MORIN BUILDING
8570 EXECUTIVE PARK AVENUE
FAIRFAX, VIRGINIA 22116-0815

Subject: Addendum # 2 to IFB #18-53, Lee Highway Transmission Main

**IFB No. 18-53
PROJECT 2545, DIVISION 2
LEE HIGHWAY TRANSMISSION MAIN**

NOTE:

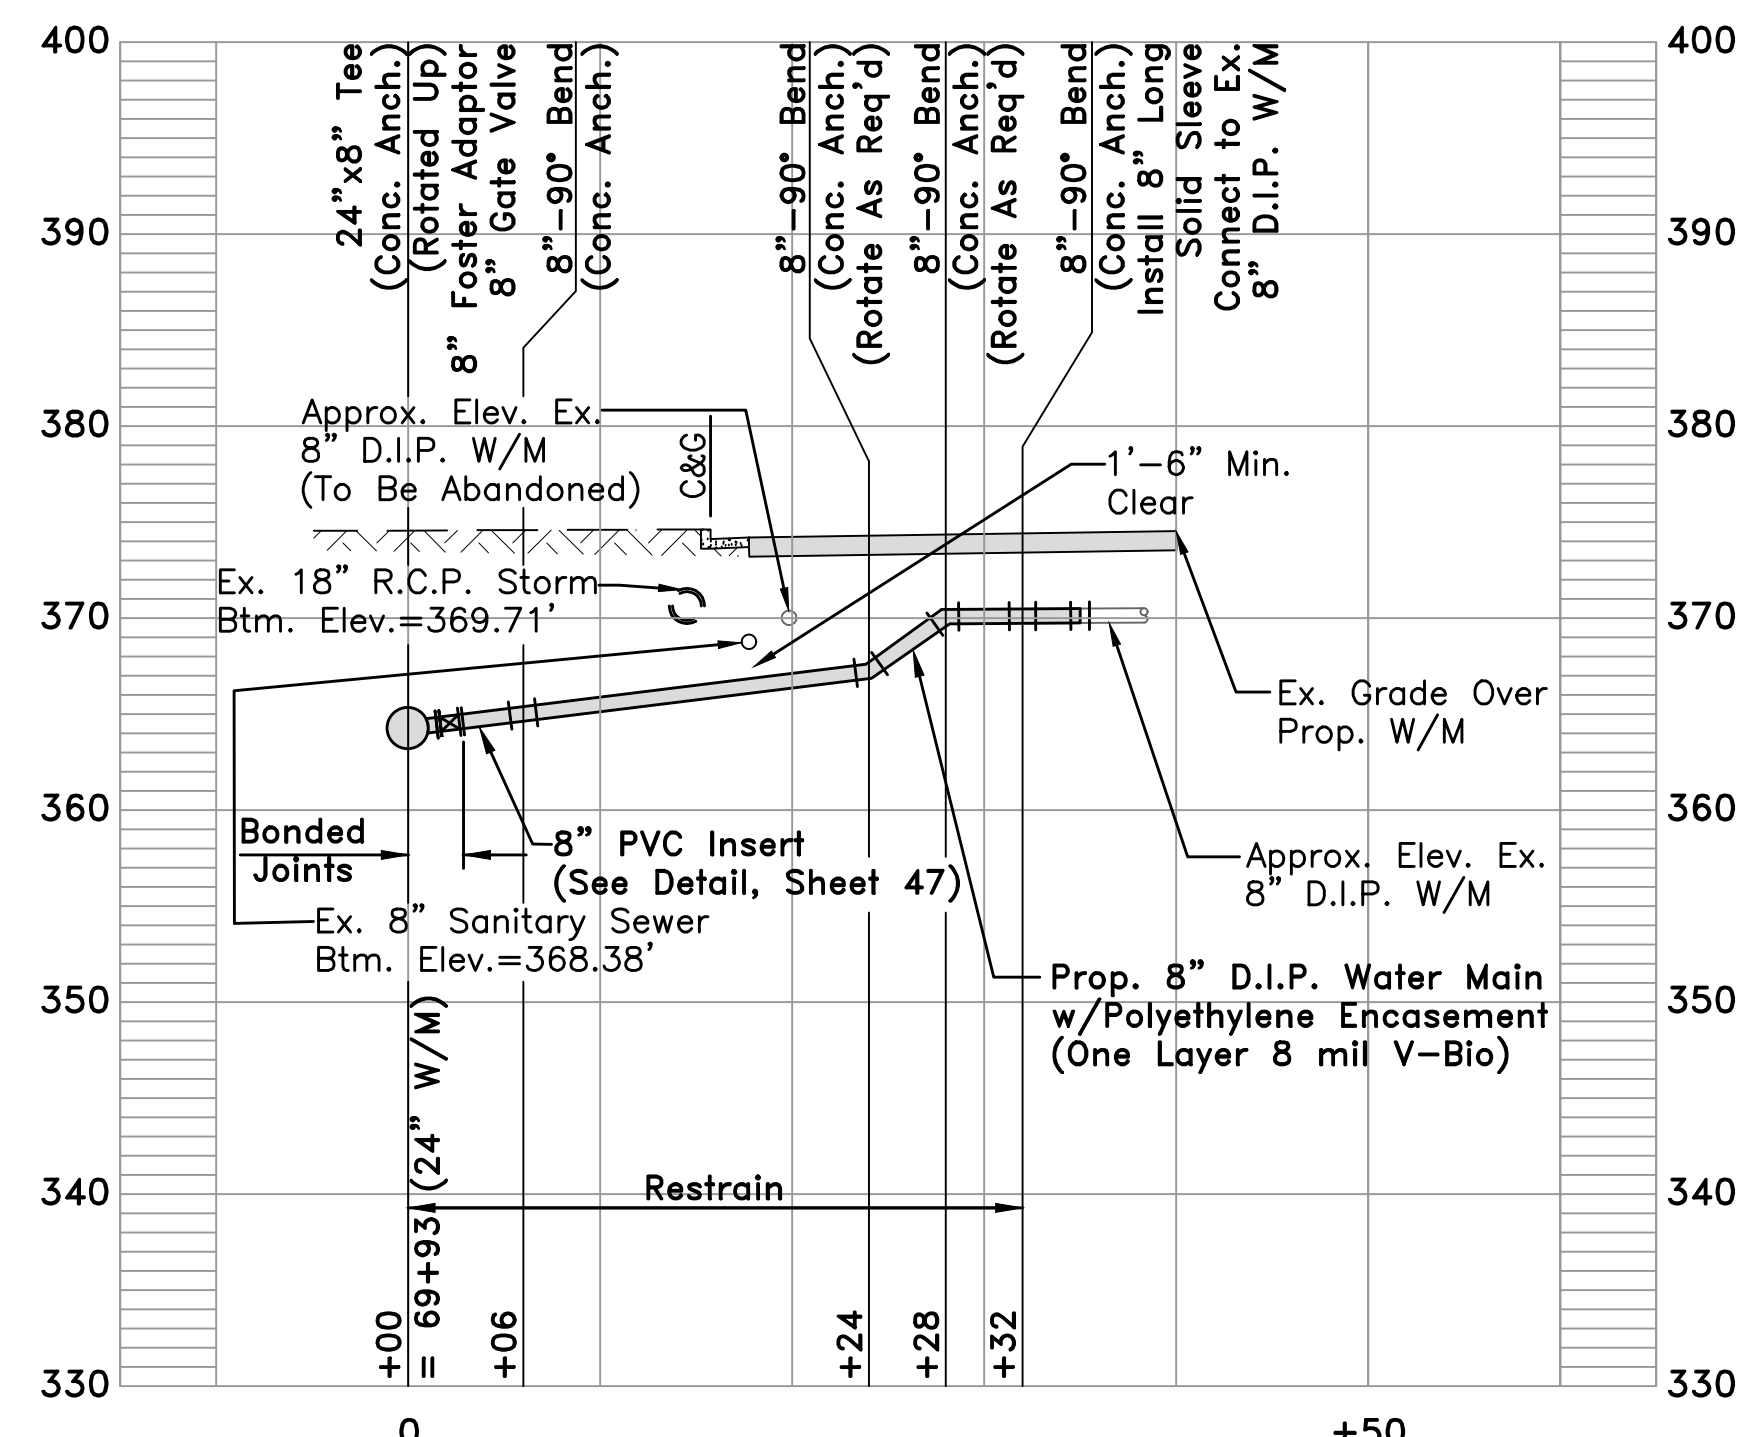
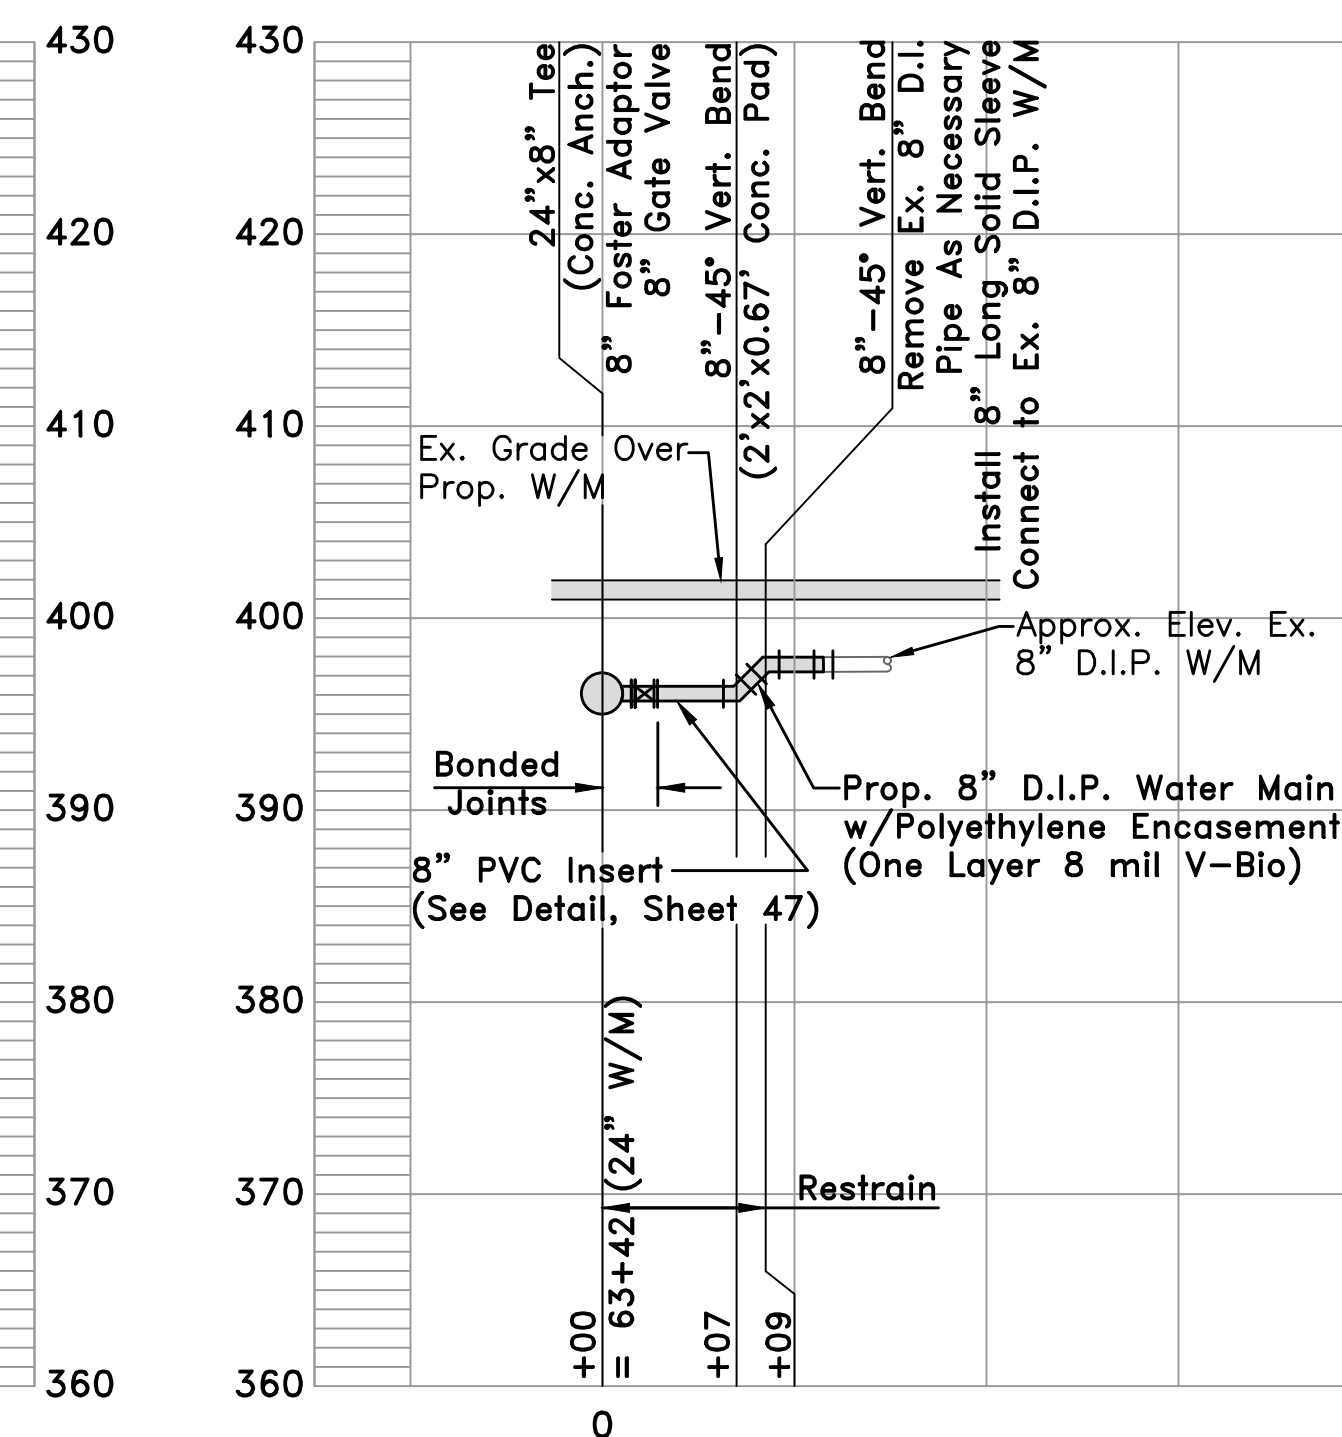
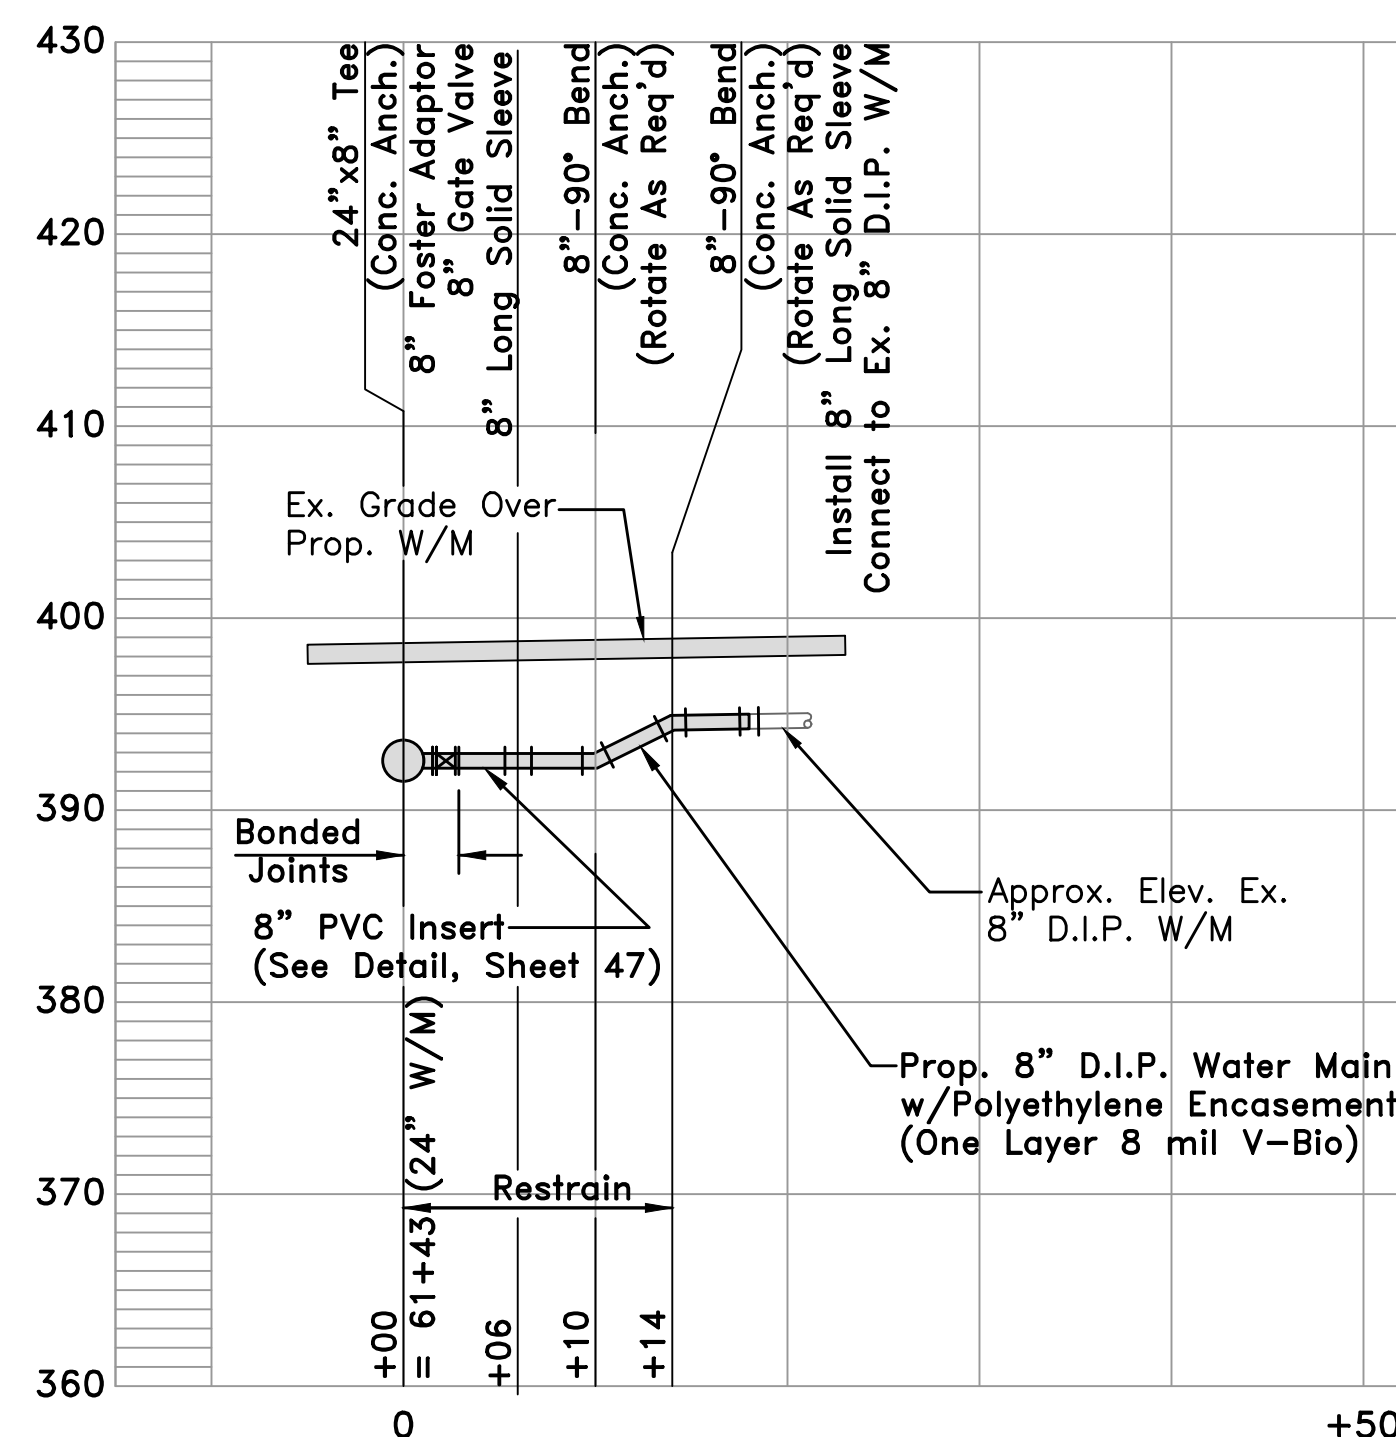
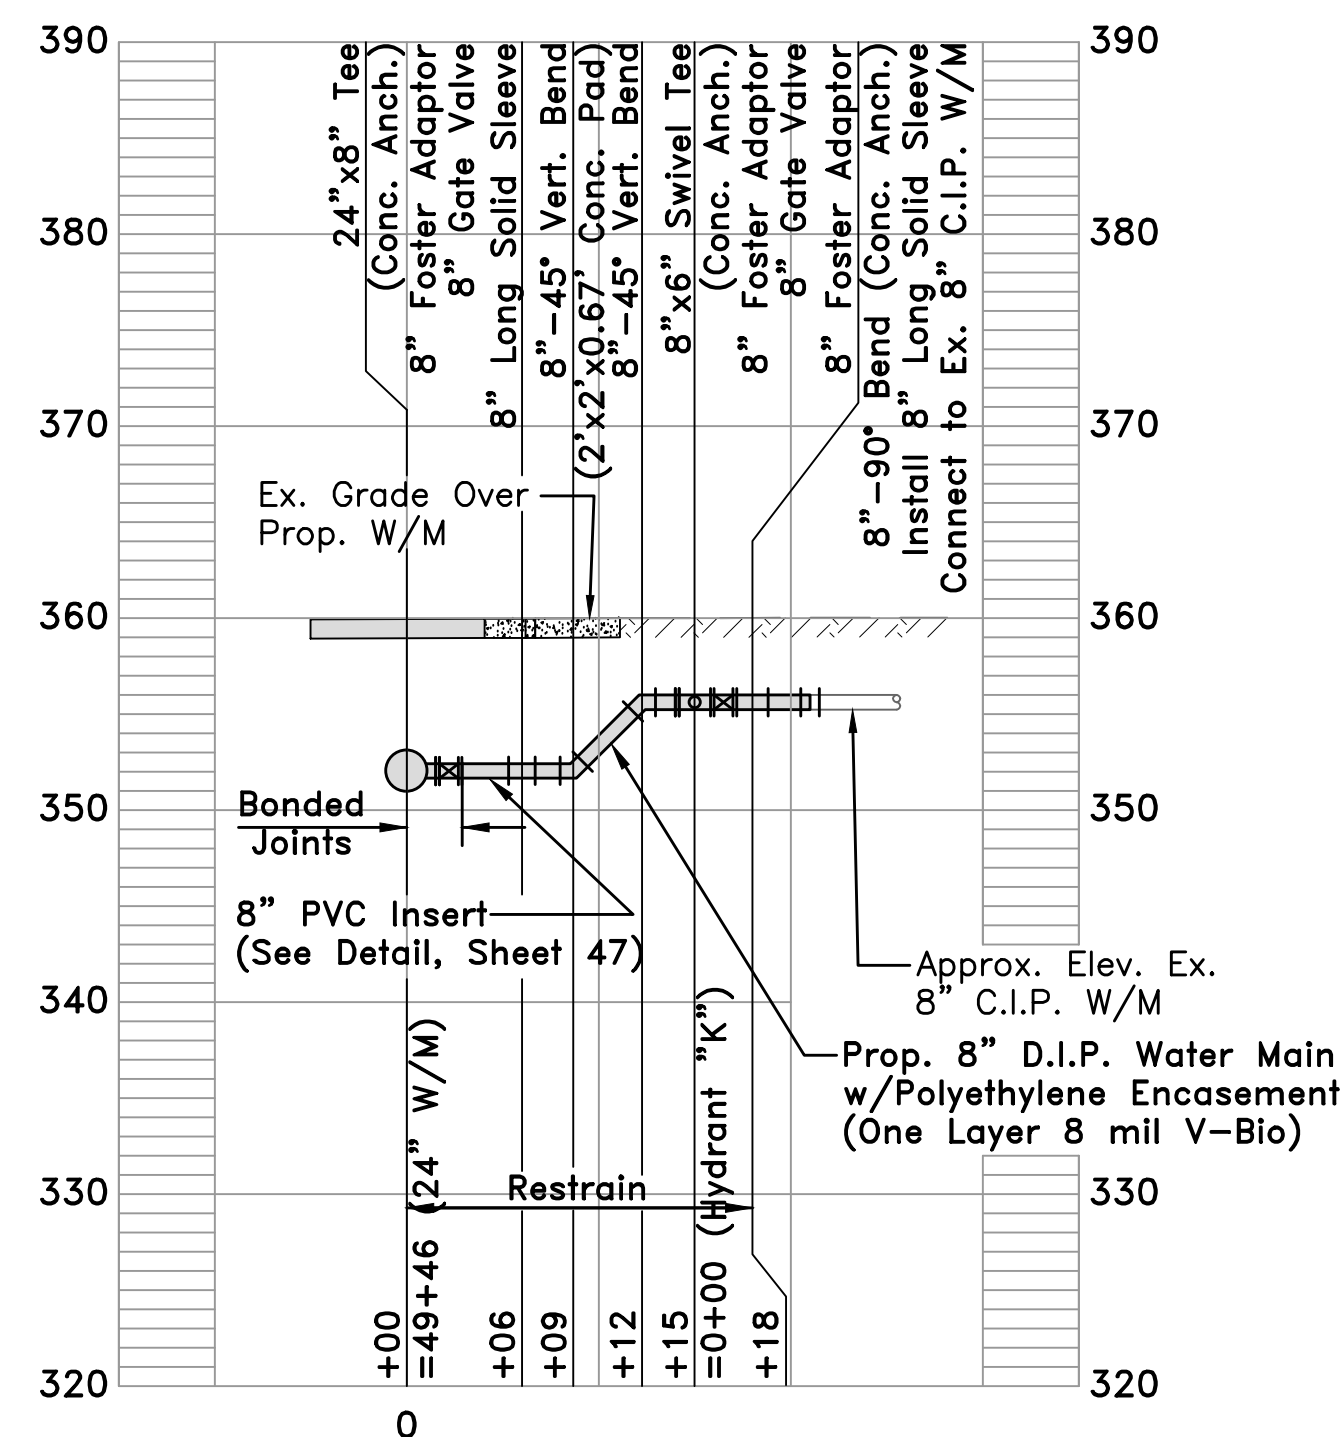
A. *Limits of proposed pavement restoration on private properties is required as indicated in the Contract Documents.*
2. Drawing 13 has two interconnections that are both labeled as Interconnection "E". Profile Drawing on Sheet 30 has the 12" Interconnection "E" at 117 LF and Sheet 30A has it at 17 LF. Which is correct?

DESIGNED:	PA	6/27/18	Addendum No. 2 – Revised Name Of 12" Interconnection "E" To "F".
DRAWN:	MAR/SRB		Added Note 7 – Access To Fairfield Crossing LLC Property.
CHECKED:	RSQ		
NO.	DATE

A. *This matter is addressed in this Addendum.*

4" Interconnection "B"
Scale: 1"=10' Horz. ; 1"=10' Vert.
(See Sheet 15 for Plan View)

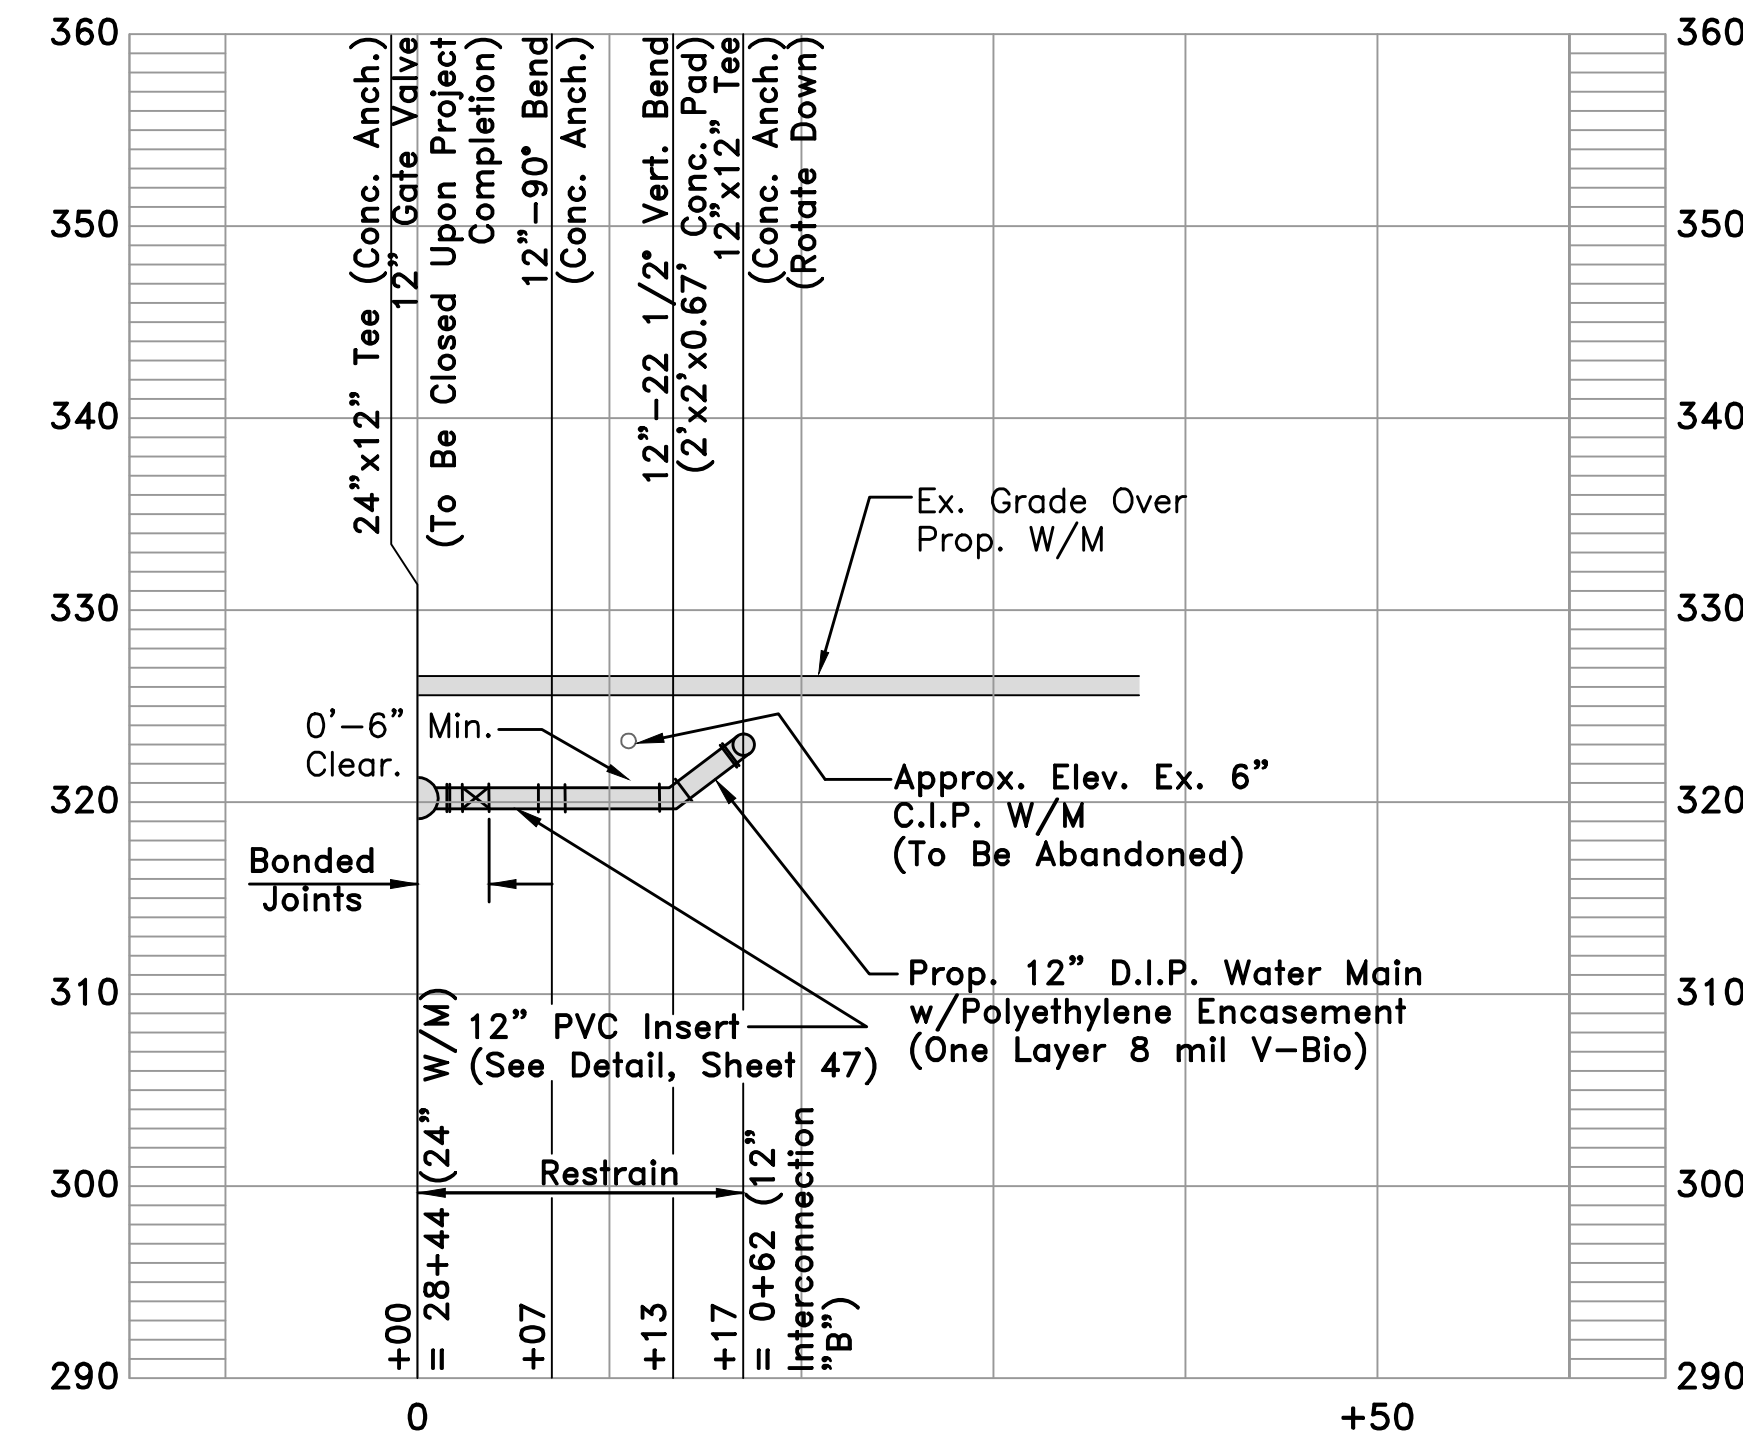
10. The profile for Interconnection "B" on Sheet 28 does not match the plan view on Sheet 13.

FAIRFAX WATER PLANNING & ENGINEERING DIVISION	DESIGNED: PA	 6/27/18	Addendum No. 2 – Revised 12” Int. ”B”
	DRAWN: MAR/SRB		To Conform Plan View
	CHECKED: RSQ		
		NO. DATE

A. This matter is addressed in this Addendum.
